HIGHWAYS ADVISORY COMMITTEE

**MAIN ROAD/ UPPER BRENTWOOD
ROAD JUNCTION
ACCESSIBILITY & SAFETY
IMPROVEMENTS FOR WALKING &
CYCLING**

Outcome of public consultation

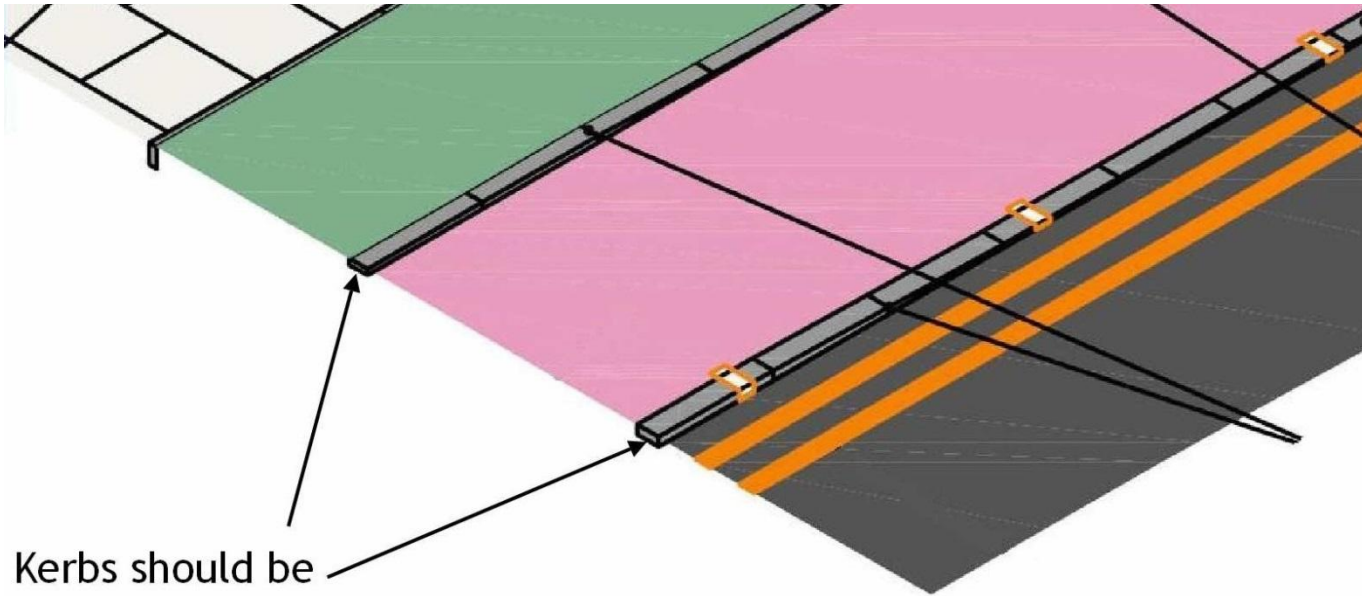
The proposed 'speed table' at the entrance to Hockley Drive should be installed with sinusoidal profile entry and exit ramps, in line with previous advice, to ensure that they are rendered cycle-friendly. Your colleague has acknowledged that there is no reason why this should not be achieved. (Please see attached diagram.)
